# **Authorized Field Change**

AFC G-03910

Subject: Certain 8600 Models, Built Between January 26, 2003 and September 17, 2003, Require 12 MM Bolts Replaced with 16MM Bolts on the Fuel Tank Crossover Bracket

Truck Model: 8600

Figure 1 Four Bolt and Nut Locations Shown with Arrows

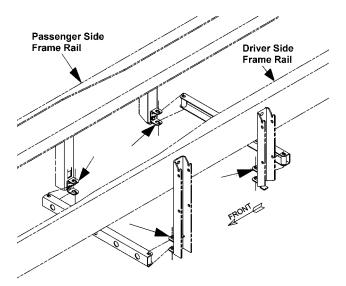
Certain 8600 Models, built between January 26, 2003 and September 17, 2003, at Garland Assembly Plant, require 12 MM bolts be replaced with 16 MM bolts due to a change to the slotted holes in the fuel tank crossover bracket.

- 1. Support the fuel tank(s) to take load off the brackets.
- 2. Remove the four 12 mm bolts and nuts (Figure 1).
- 3. Install four new 16 mm bolts and nuts (Figure 1). Tighten to 173 to 211 Lbf- Ft (235 to 286 Nm).
